TRANS/WP.29/2003/84  
30 July 2003

PROPOSAL FOR DRAFT SUPPLEMENT 6 TO THE 03 SERIES OF AMENDMENTS TO  
REGULATION No. 44

(Child restraints)

Transmitted by the Working Party on Passive Safety (GRSP)

Figure 1

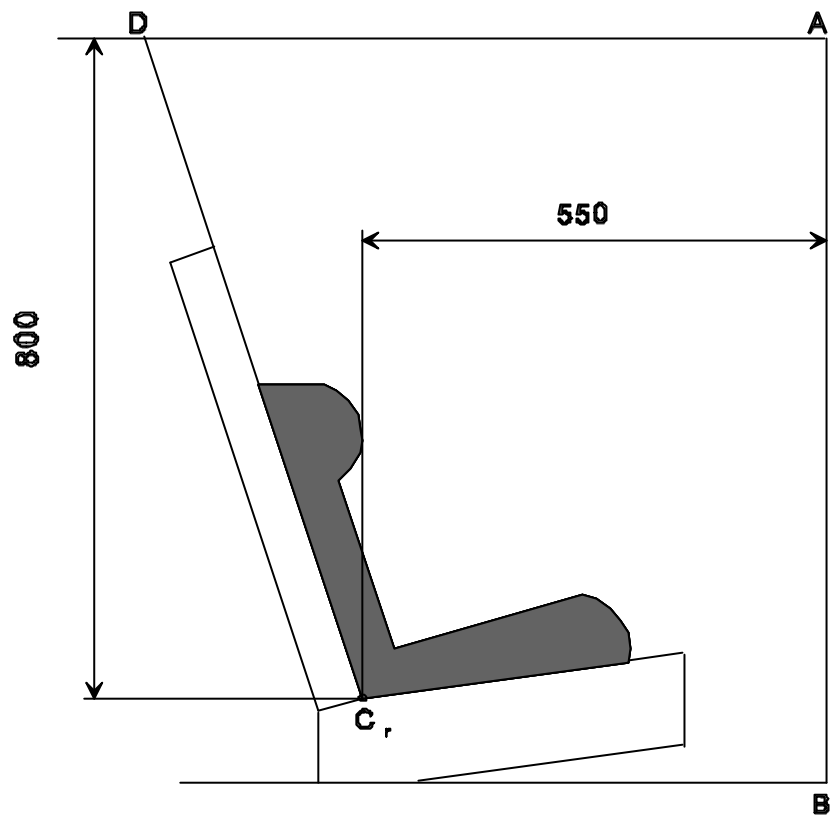
Paragraph 7.1.4.4.1.1., amend to read:

"7.1.4.4.1.1. Forward facing child restraints: the head of the manikin shall not pass beyond the planes BA and DA as defined in Figure 1 below. This shall be judged up to 300 ms or the moment that the manikin has come to a definitive standstill whatever occurs first.

**Figure 2:  
Arrangement for testing  
a rearward-facing device**

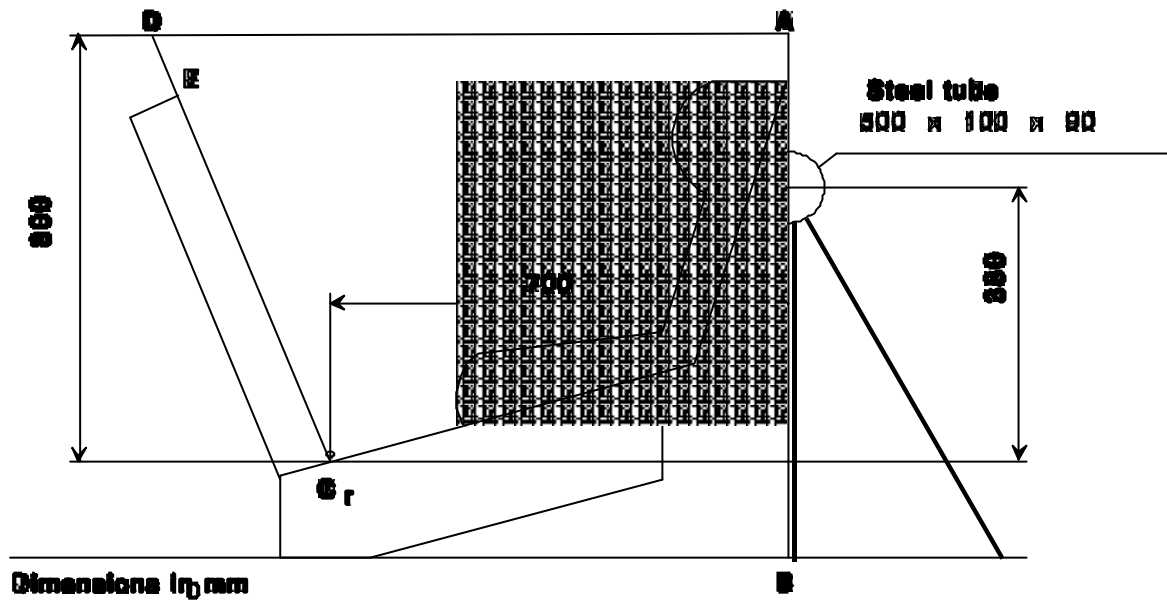
Paragraph 7.1.4.4.1.2.1., amend to read:

"7.1.4.4.1.2.1. Child restraints supported by dashboard: the head of the manikin shall not pass beyond the planes AB, AD and DCr, as defined in Figure 2 below. This shall be judged up to 300 ms or the moment that the manikin has come to a definitive standstill whatever occurs first.

Figure 3

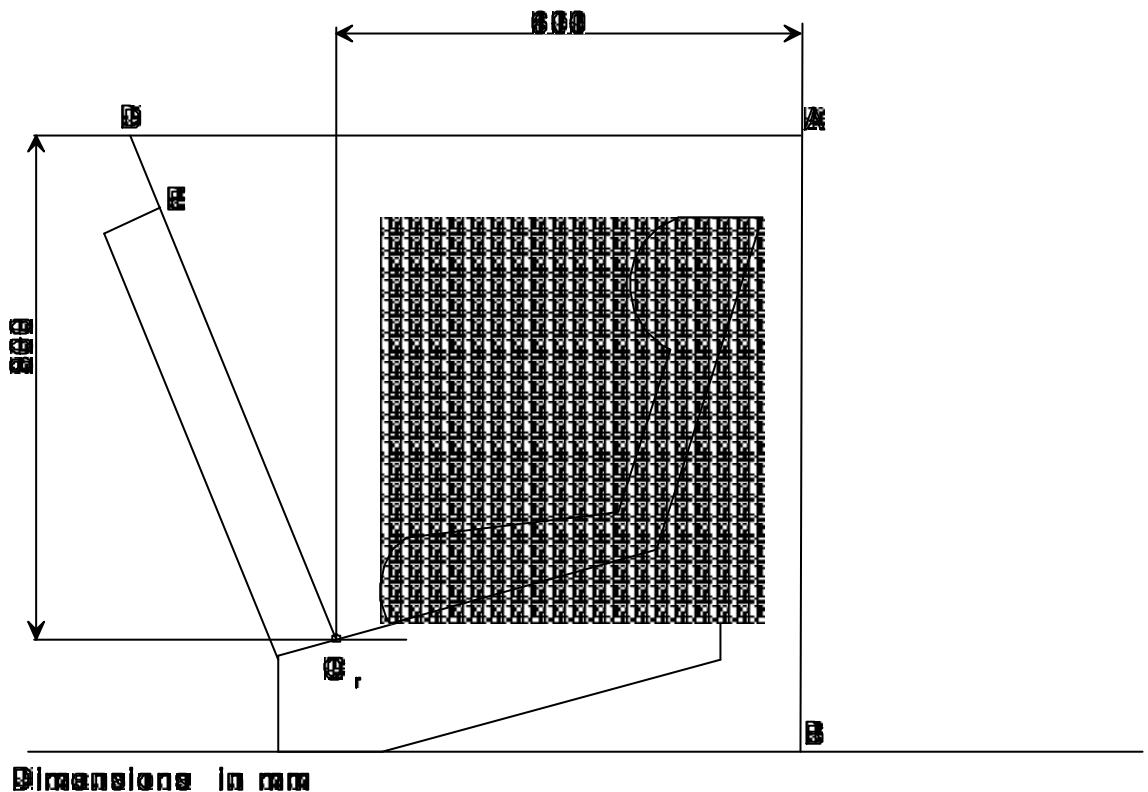
Paragraph 7.1.4.4.1.2.2., amend to read:

"7.1.4.4.1.2.2. Child restraints in group 0 not supported by the dashboard, and carrycots: the head of the manikin shall not pass the planes AB, AD and DE as shown in Figure 3 below. This shall be judged up to 300 ms or the moment that the manikin has come to a definitive standstill whatever occurs first.

Figure 1: Standard seat belt configurations"

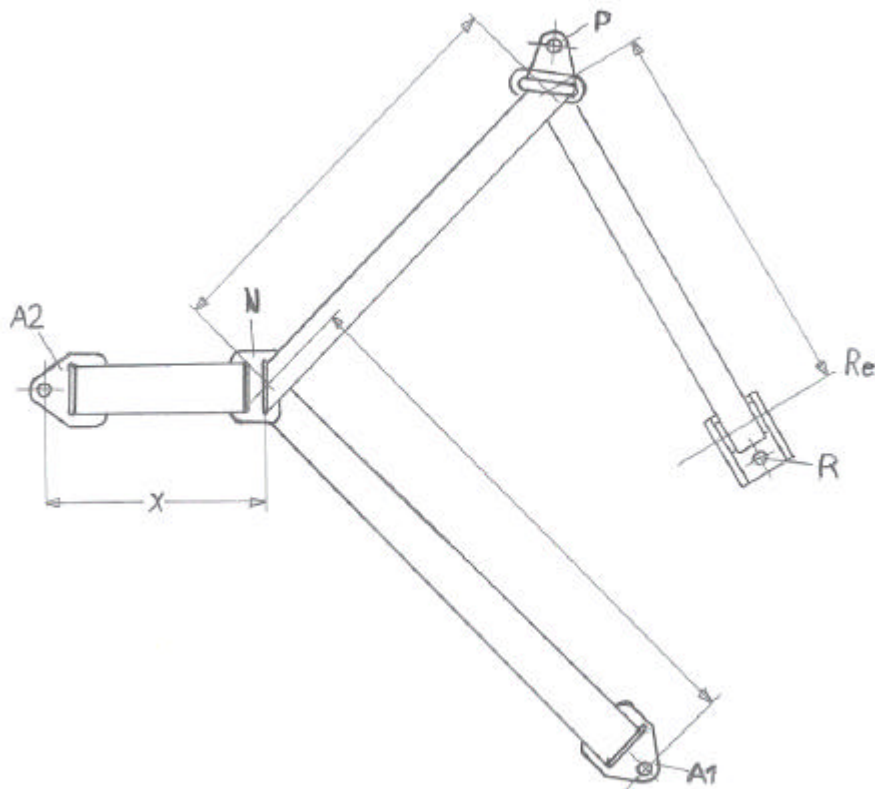
Figure 1, amend to read:
